**SOUTHERN CALIFORNIA EDISON
KERN RIVER NO. 3 HYDROPROJECT**

DOCKET NO. P-2290-122

**KERN RIVER BOATERS' COMMENTS, STUDY
REQUESTS, AND INFORMATION REQUESTS IN
RESPONSE TO PRELIMINARY APPLICATION
DOCUMENT AND SCOPING DOCUMENT ONE**

Figure 1: Flows Above Fairview Dam, Summer 2021

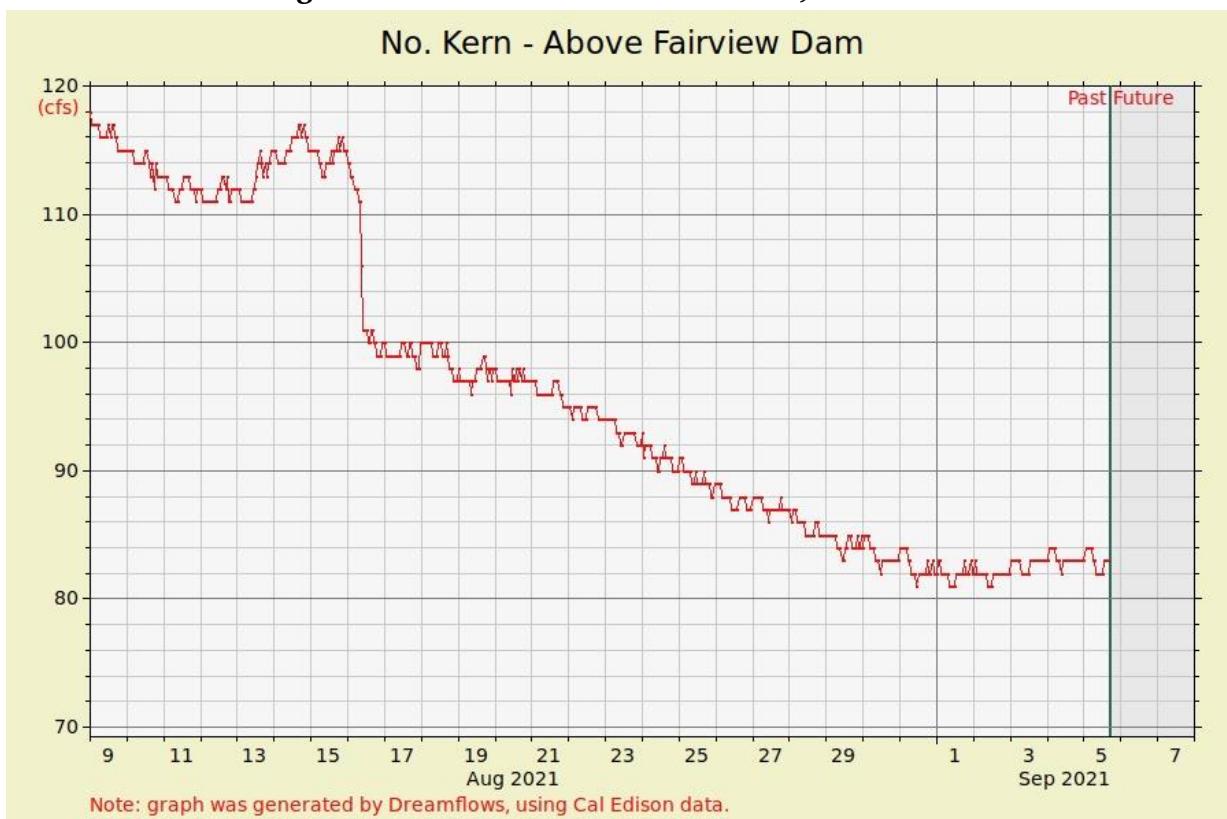
It is inaccurate and misleading to refer to Edison’s diversion of the first 35 cfs at Fairview Dam — which Edison has since increased to 40-45 cfs without a license amendment²³ — as a “hatchery flow” or to otherwise characterize the purpose of the diversion of that amount of water as being driven by hatchery operations. The hatchery does not require 35 (or 40 or 45) cfs to operate; the KR3 hydroelectric project does. Indeed, the hatchery has been closed for all of 2021.²⁴ Nevertheless, as the following graphs show, Edison continued diverting the first 42-43 cfs from the river, even as flows below Fairview Dam fell below 40 cfs during the hottest summer months when the natural fishery is most at risk:

The record demonstrates that the central purpose of the first-in-priority 35 (now 40-45) cfs diversion is to provide for minimum power generation — not hatchery operations — and it should be licensed and characterized that way.

Figure 3: A recent week (summer 2021) of extreme low flows in the fishery below Fairview Dam. Incoming flows above the dam were 80-84 cfs, but more than half was diverted for minimum power generation; note also, the hatchery was closed and had been closed since December 2020

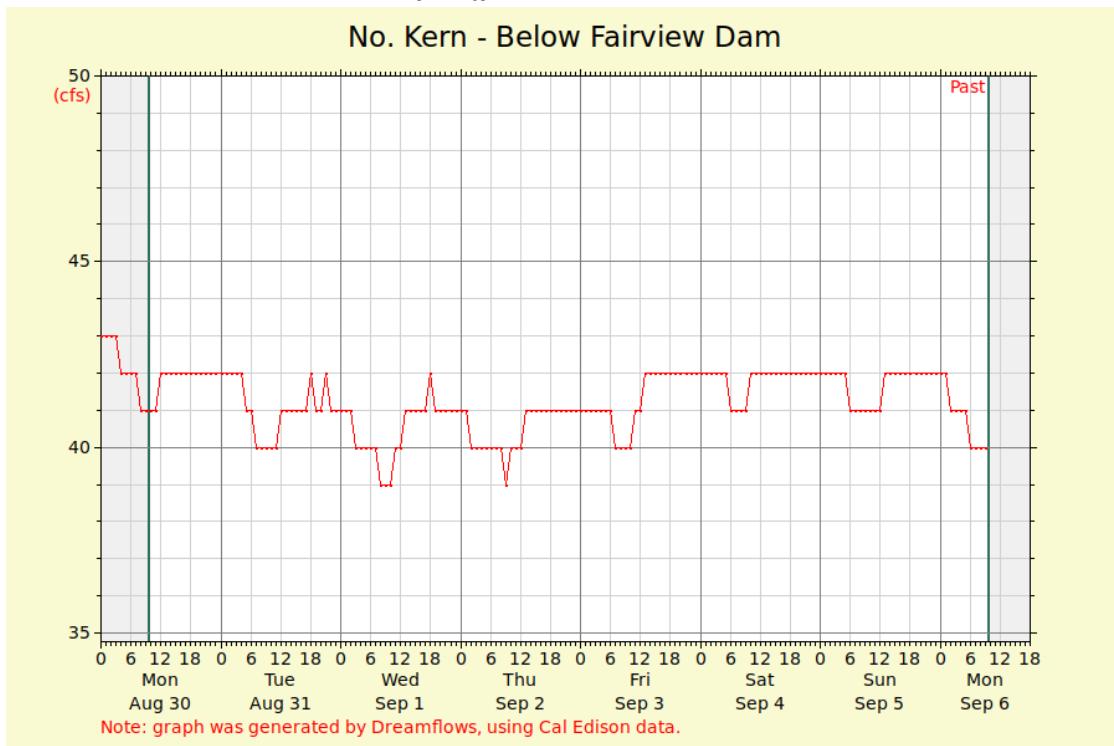
Instream flows are critical to the health of a fishery. The “buffer” taken on top of the minimum generation flow comes at the natural fishery’s expense when the fishery is most at risk: hot summer months of dry, low water years. In the summer of 2021, for instance, flows in the natural fishery dropped as low as 39 cfs. The buffer amounted to an *additional* 13-25% reduction of the fishery’s flow, on top of the near 50% reduction entailed by the first-in-line minimum power diversion of 35 cfs.

Figure 13: KR3 Mean Annual Generation, 2001-2020

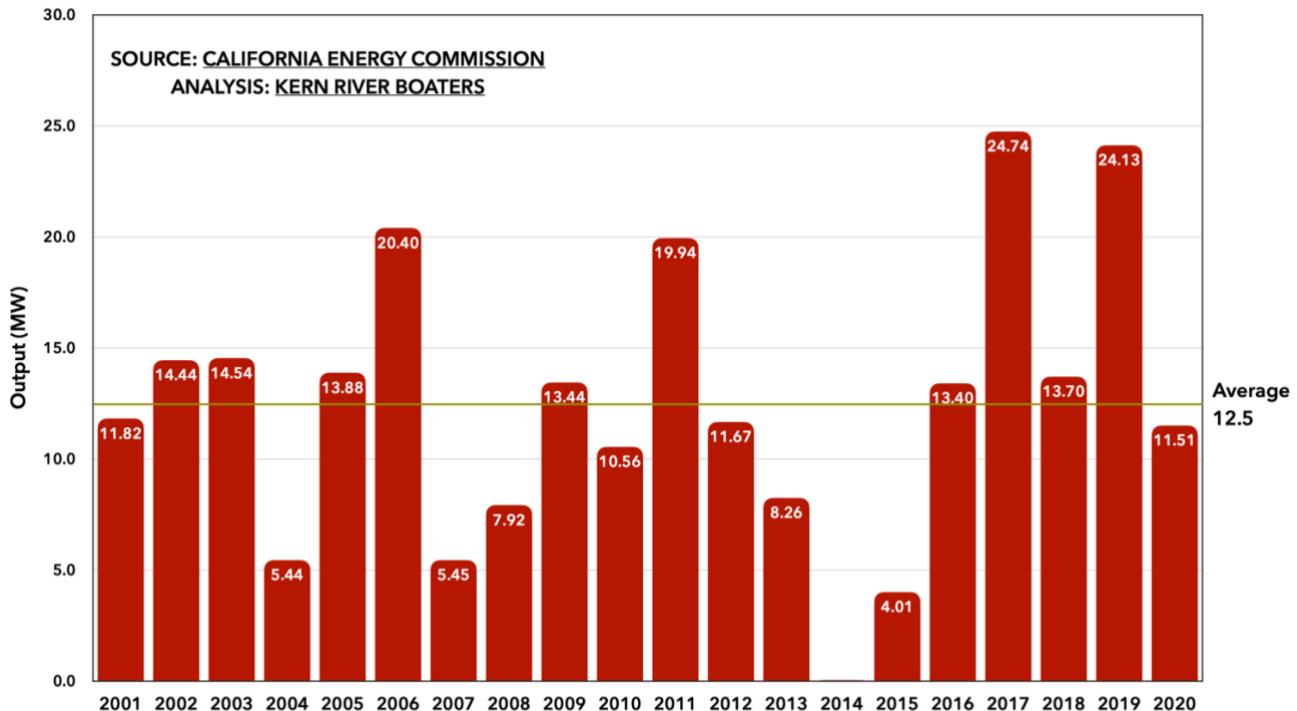
The project’s mean annual rate of output since 2001 has been about a third of its capacity, or 12.5 MW, with large fluctuations from zero (2014) to just under 25 MW (2017)⁵⁹:

Figure 17: Mean Inflow at Fairview Dam, 1997-2020⁶²

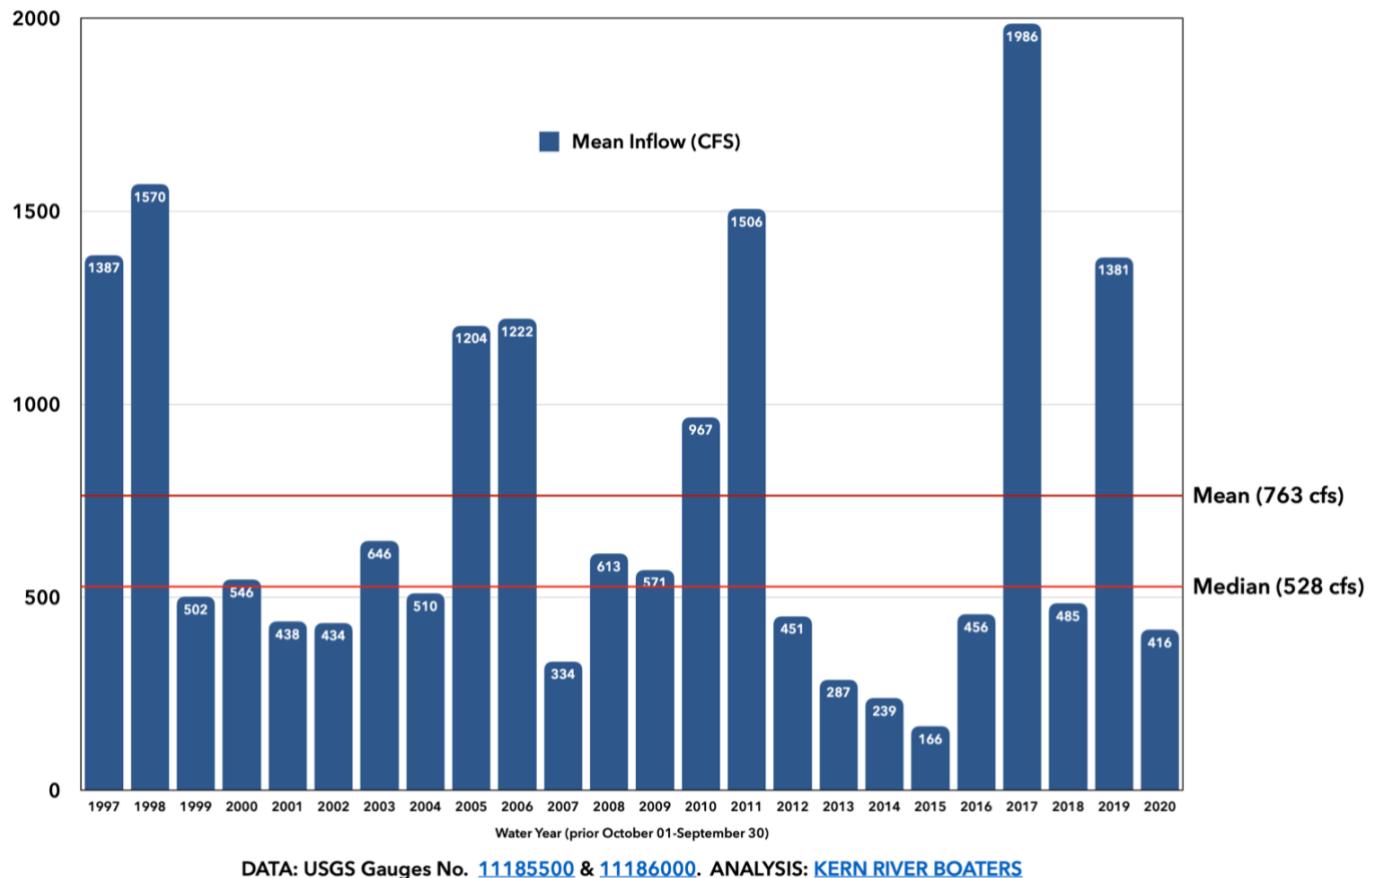
KRB: Edison's POR is bookended by two consecutive high water years on the front end (1997 and 1998) and two of three years on the back end (2017 and 2019):

Data for water year 2020 — a dry year, which Edison chose not to include — has been available at USGS, and KRB includes it. The figure above illustrates a wide range of values between water years, from a mean flow of 166 cfs at Fairview Dam in the lowest year to a mean more than an order of magnitude greater in the highest: 1,986 cfs.

Figure 24: NFKR Median Exceedances, 1997-2020

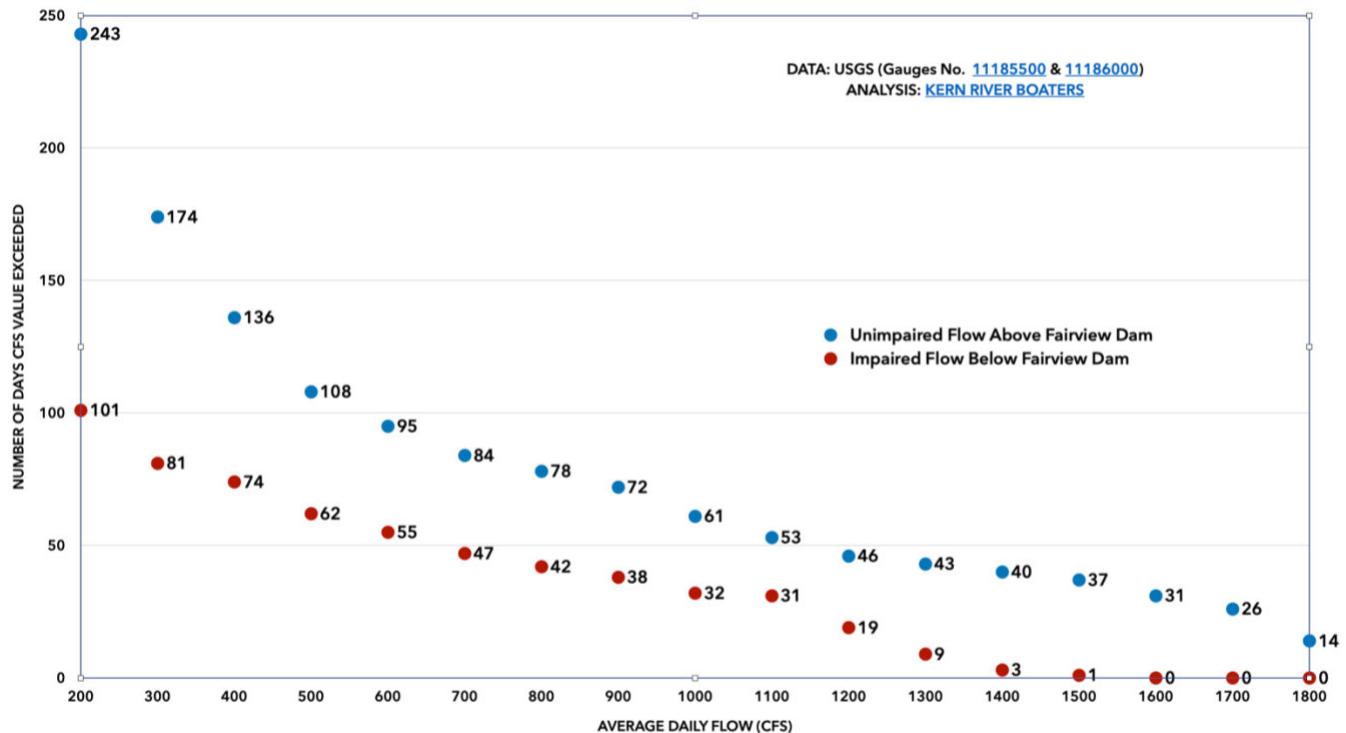
The project's effects on peak flows can be seen on the right half of *Figure 24*; its effects on shoulder flows can be seen left of center; and its effects on enjoyable perennial flows can be seen on the left. Note again that these figures do not reflect peak diurnal flows. These figures also fail to capture the full impact of KR3 on NFKR recreation because the project was offline for 1,455 of the 8,766 days of the data set and partially offline for at least hundreds more.

Figure 25: Comparison of KR3 Fish Flow Requirements, USFWS v. Settlement⁶³

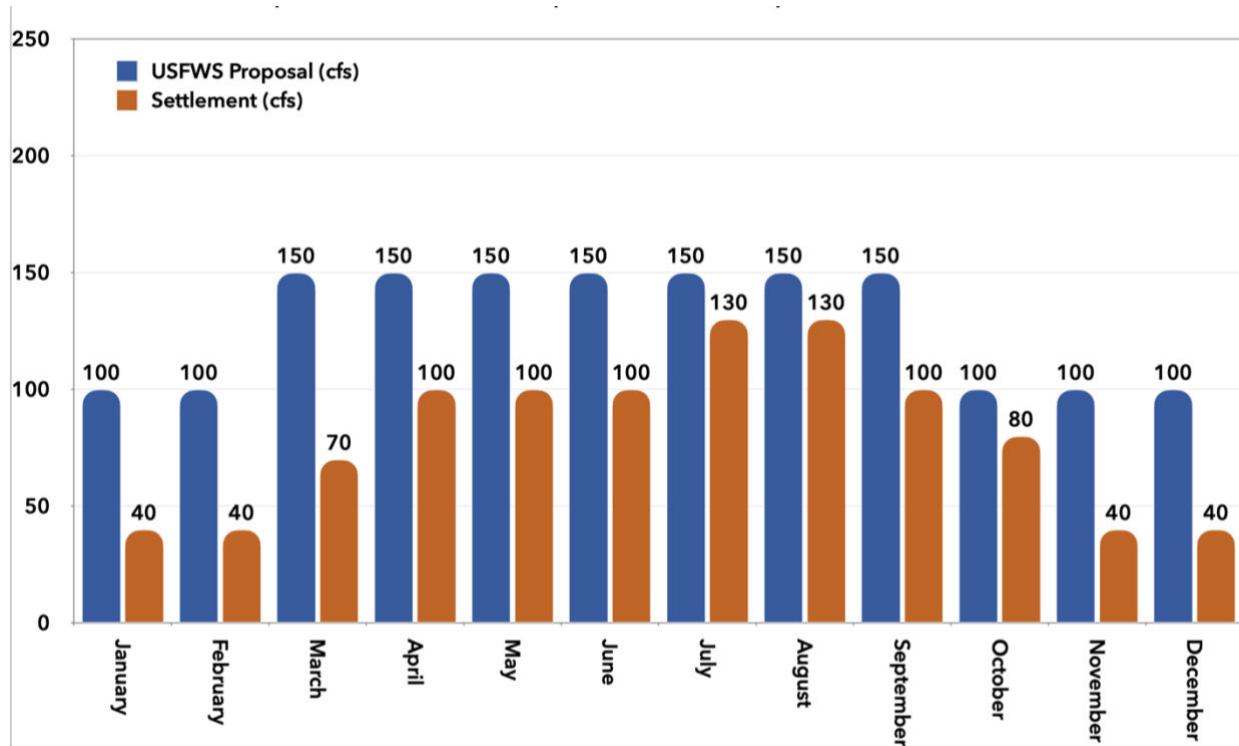
KRB: In the last proceeding, USFWS proposed a significantly more robust MIF:

Figure 26: NFKR Segment 1 (Upper Half) IFIM Habitat Evaluation, 1991⁶⁹

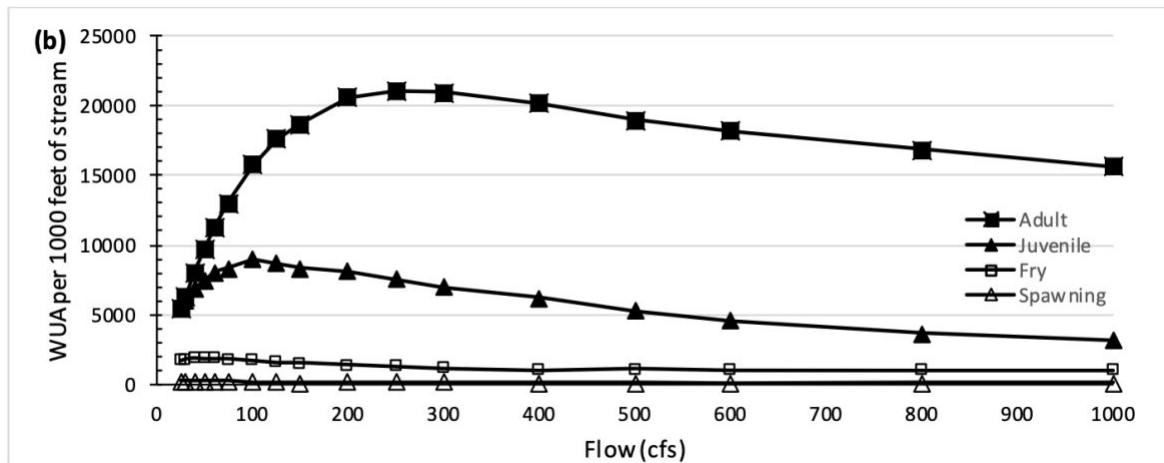
KRB: The 1991 IFIM study showed that life prospects for adult rainbow trout in the fishery below Fairview Dam begin to decline when flows move towards 200 cfs from 250 (Segment 1) or 400 (Segment 2) cfs. Life prospects then sharply plummet as flows fall below 200 cfs:

Figure 44: Median NF Kern Annual Exceedances, 1997-2020

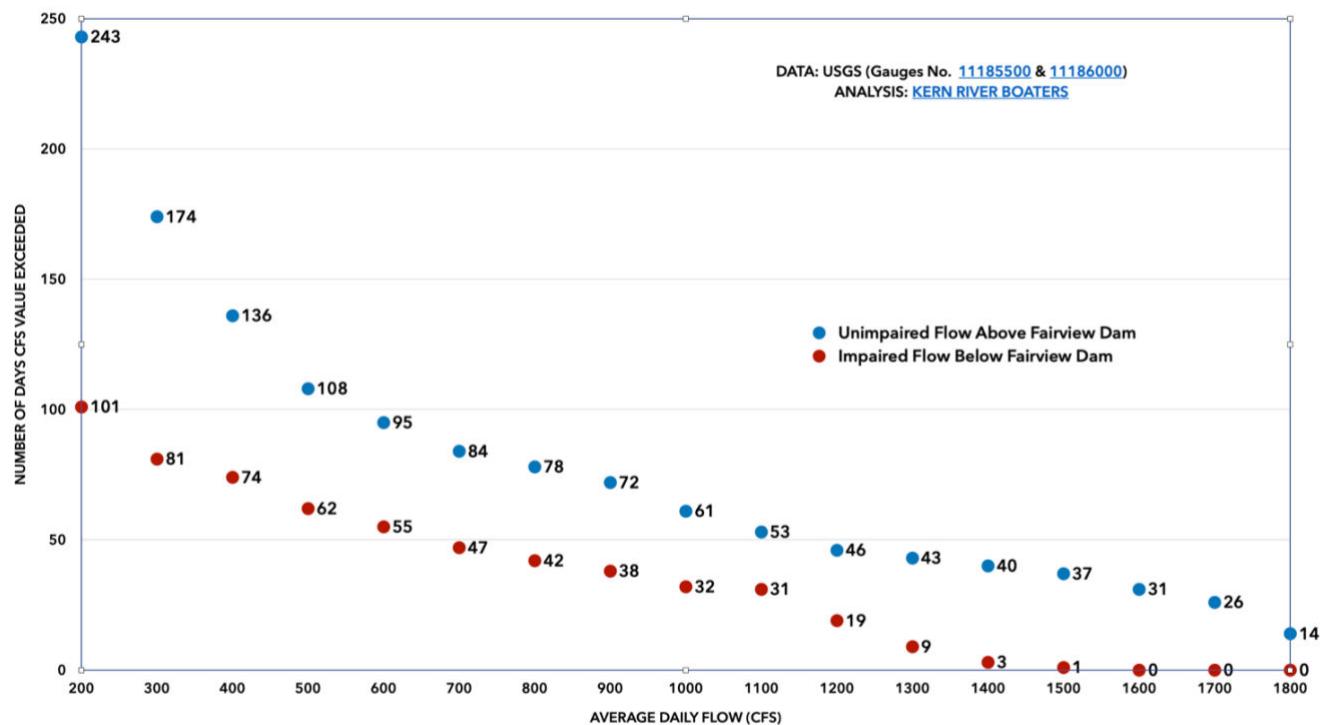
Median annual flows for the term of the present license (1997-2020) show that 243 days have an average daily flow above Fairview Dam of 200 cfs or more. That figure drops to only 101 days below the dam due to project operations:

Recall again that these figures are confounded because Edison has not provided peak daily flow information for the POR, because the project was offline for 1,455 of the 8,766 days in this record, and because it was partially offline for at least hundreds more. Even so, these figures show a vast inventory of days at all water levels upon which the NFKR would naturally offer whitewater boating opportunities that are denied to the public due to the operation of the project.

Figure 45: Percentage of NFKR Exceedances Lost to KR3 Operations, 1997-2020, by Water Year Type (Thirds)

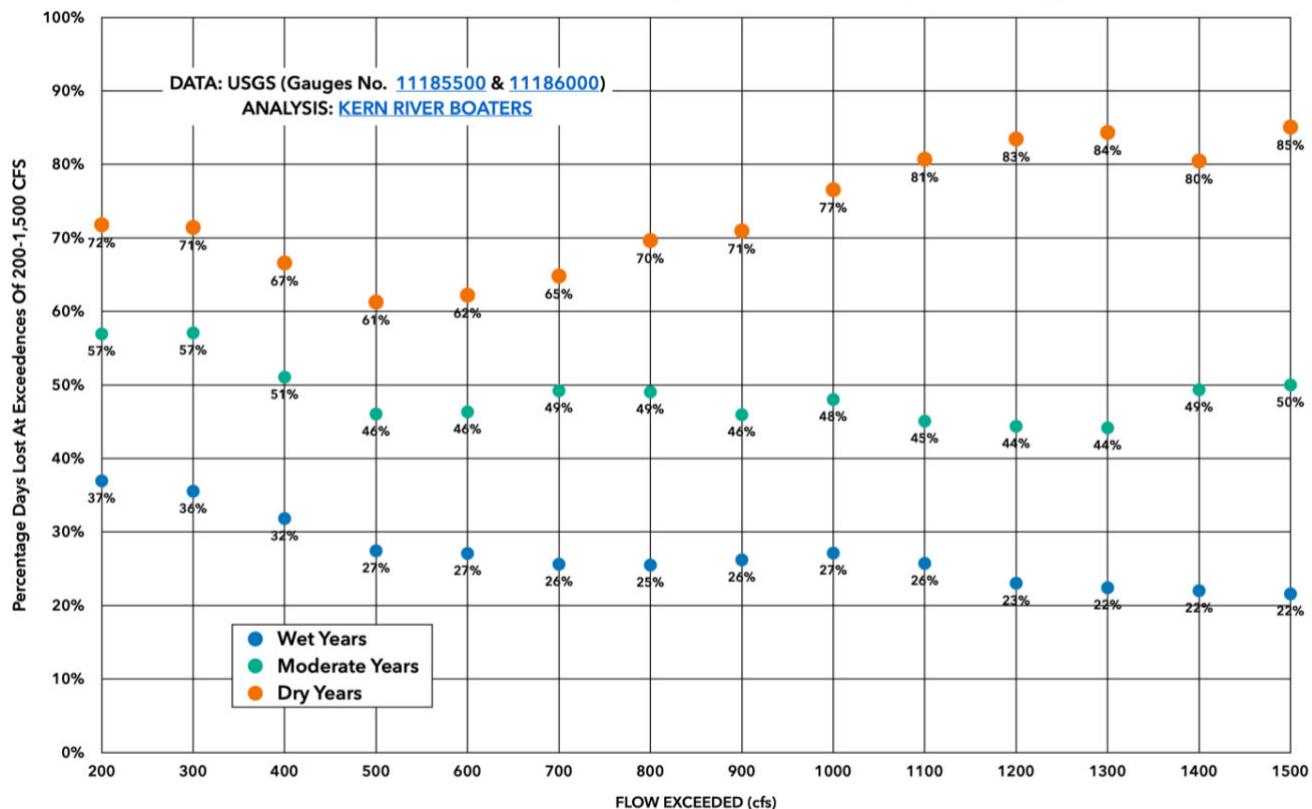
Finally, it is important to note that the project takes its biggest chunk out of recreational opportunities on the NFKR in low water years. The following chart compares the percentage of exceedances in the dewatered reach lost to project operations in high, moderate, and low water years over the POR:

Figure 49: NFKR Rec Flow Days, 2005-2021

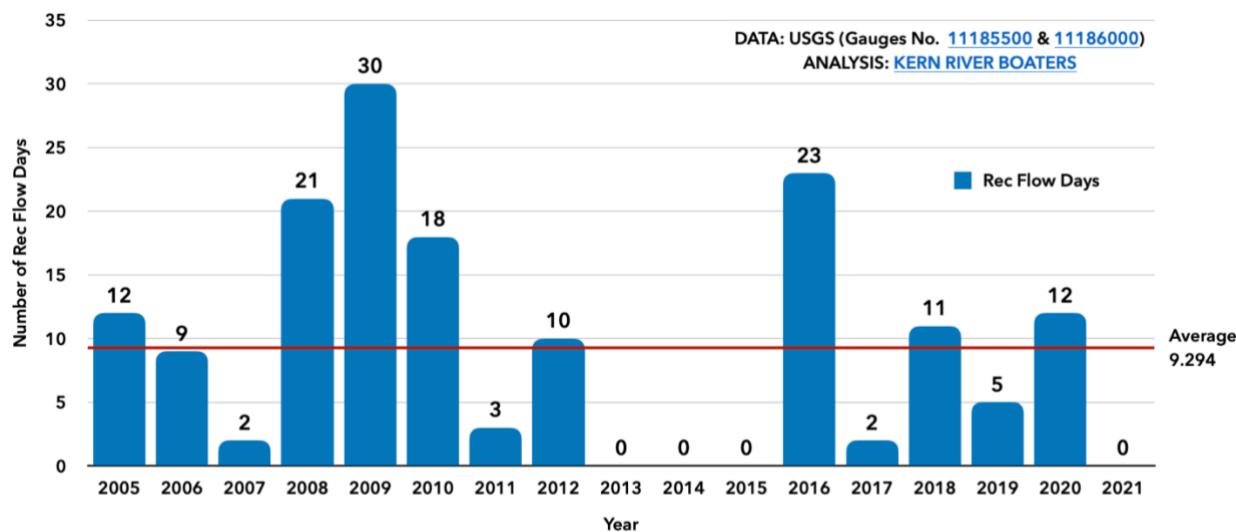
Since Edison's obligation on a rec day falls somewhere from 0-300 cfs based on incoming flows — which over time are random in the relevant ranges — Edison on average need give up only 150 cfs from operations for a rec day. That is a small amount of additional water for recreation on this world class river. And the rec day loss to Edison only lasts for seven hours plus ramping time (about 1.5 hours worth at 150 cfs). The trifling nature of this obligation is underlined when one realizes that since this rec flow schedule was adopted, there have been an average of less than 10 rec flow days per year:
